ADDENDUM NO. 1

April 23, 2024

Whiteland Community High School Phase 2A
300 E. Main Street
Whiteland, IN 46184

This Addendum consists of Pages ADD 1-1 through ADD 1-2 and attached Specification Sections 01 21 00 – Revised Contract Allowances, Logistics Plan, Guideline Schedule, and Lancer Associates Architecture Addendum No. 1, dated April 23, 2024, consisting of 63 Pages, Specification Sections 11 68 33 – Field Events & Athletic Equipment, 32 18 23 – Track Surfacing Latex System, 32 31 13 – Chain Link Fencing and Gates, 33 14 17 – Site Water Utility Service Laterals, 33 42 00 – Stormwater Conveyance, and Drawings 100, 210, 302, 303, 400, 401, 402, 403, 500, 501, 600, 601, 700, 900, 901, 902, 903, 904, 1004, L101, L102, L201, L202, L402, ES102, ES103, and ES301.

SITE LAYOUT PLAN -
PHASE 2A

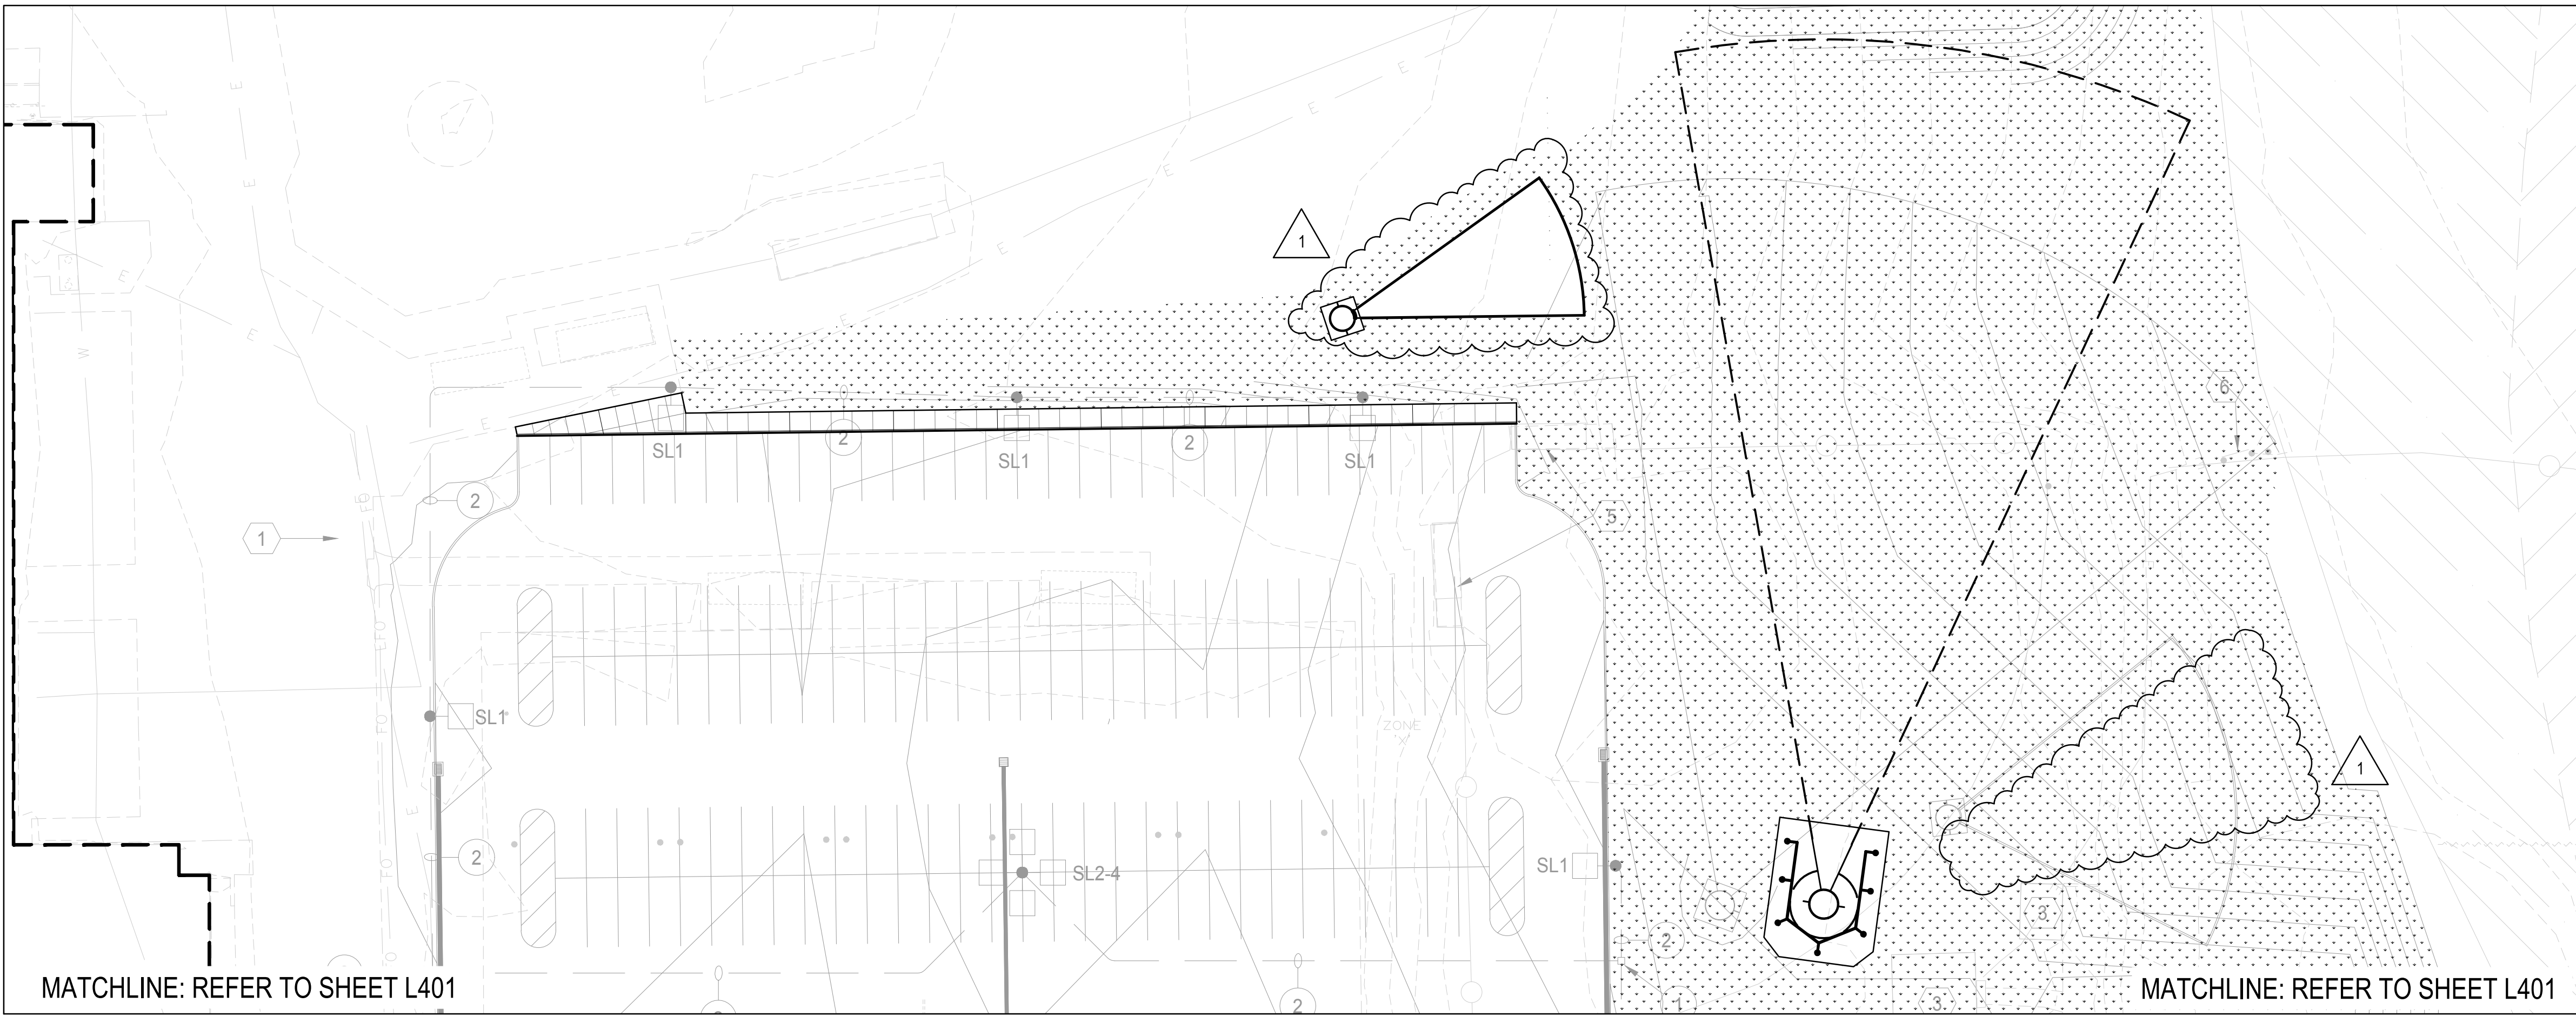
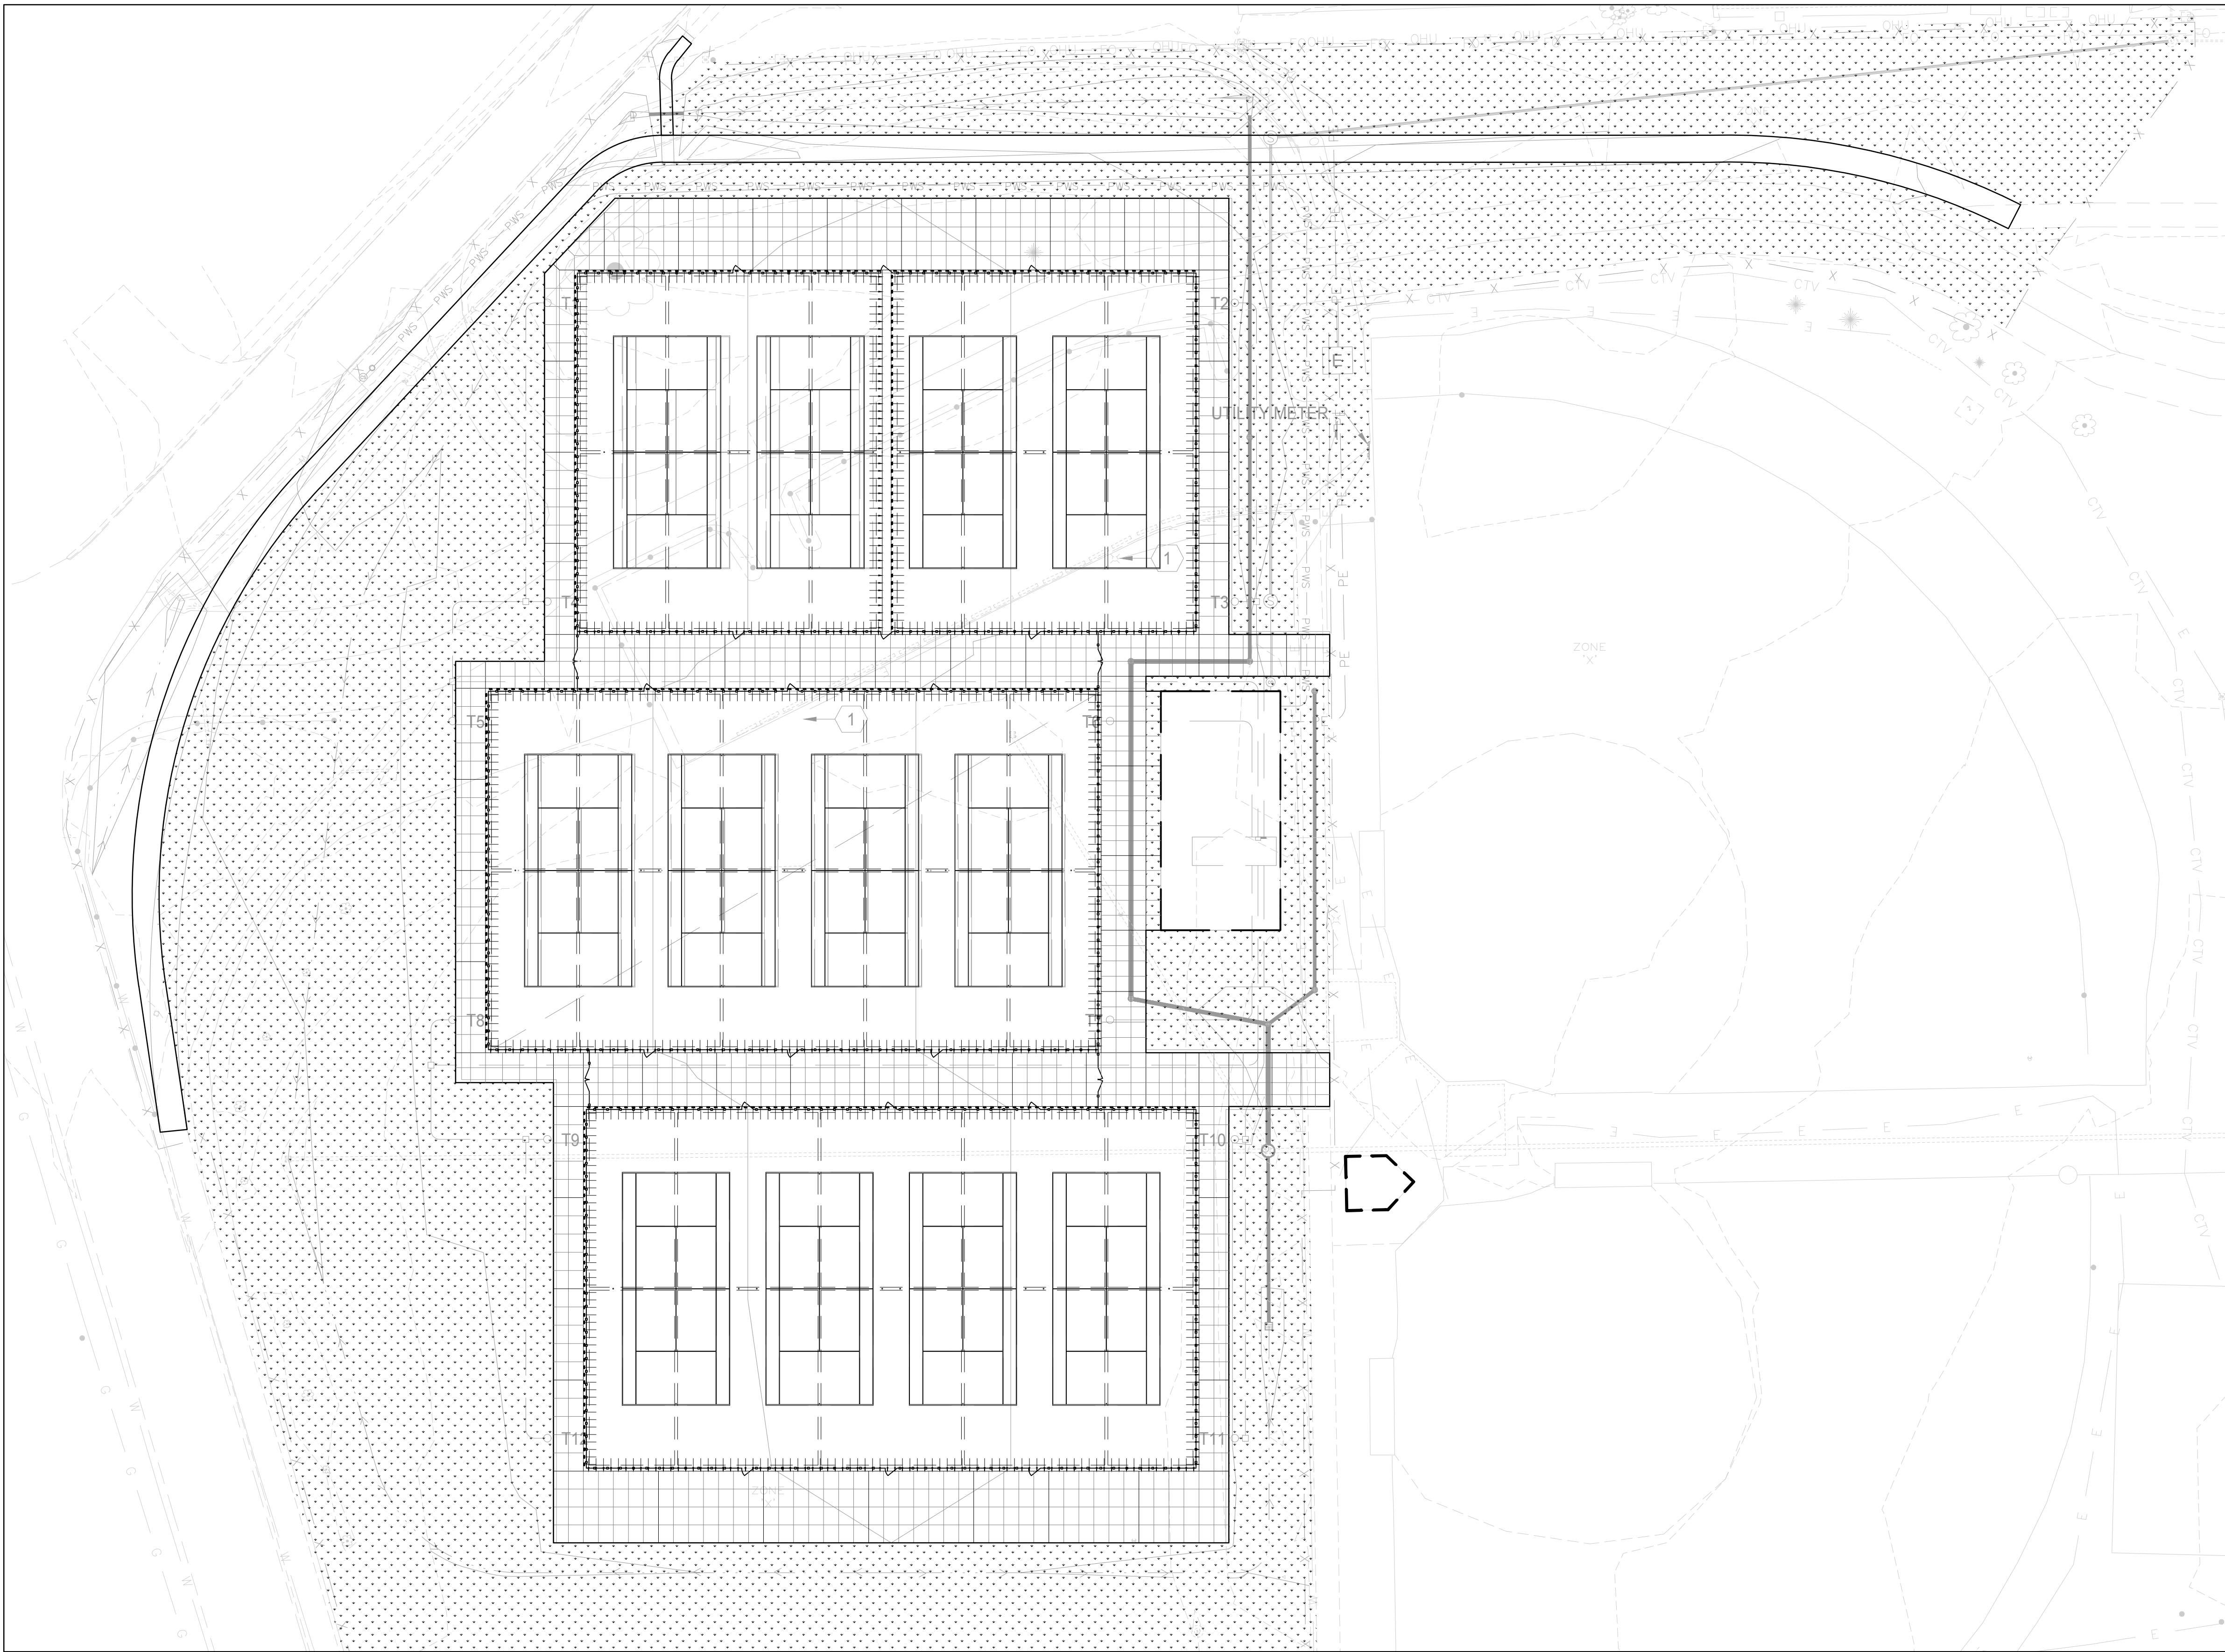
- Shot put layout revised.
- Plan updated to show asphalt trail by tennis.

ELECTRICAL DEMOLITION SITE PLAN
SCALE: 1" = 50'-0"

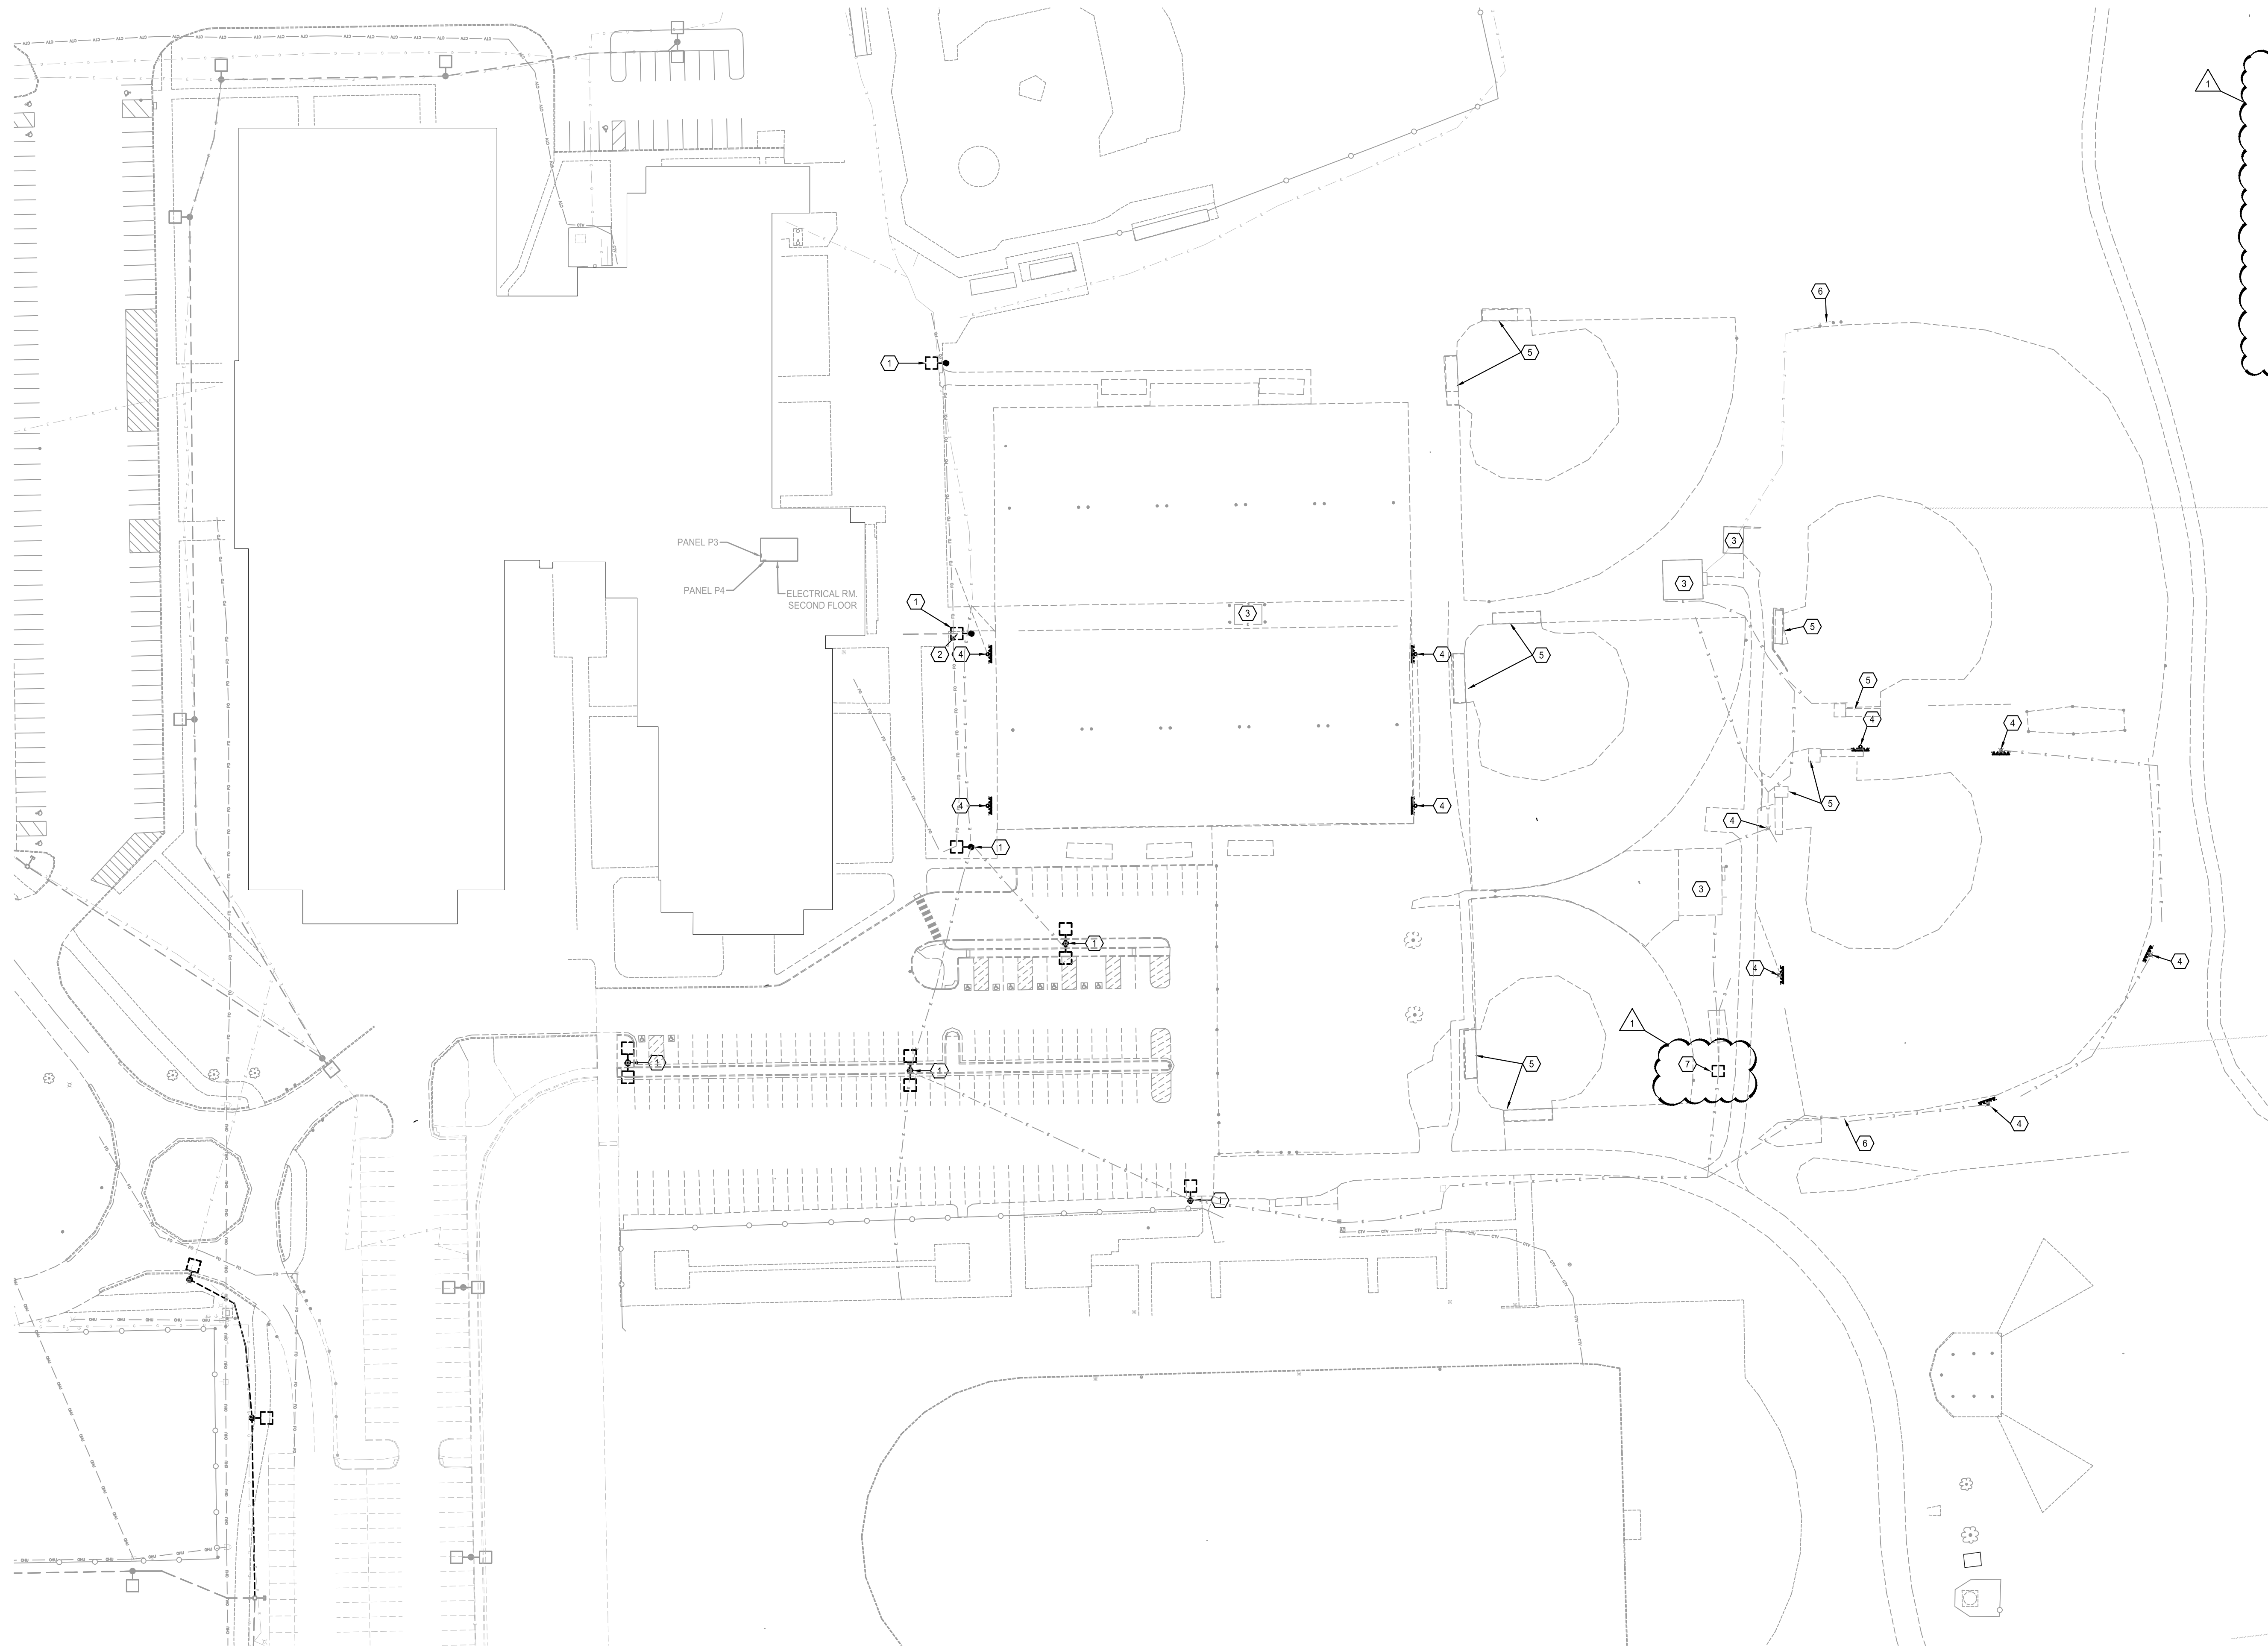
- a) Drawing #1: Added plan note #7.
- b) Plan notes: Revised Plan notes.
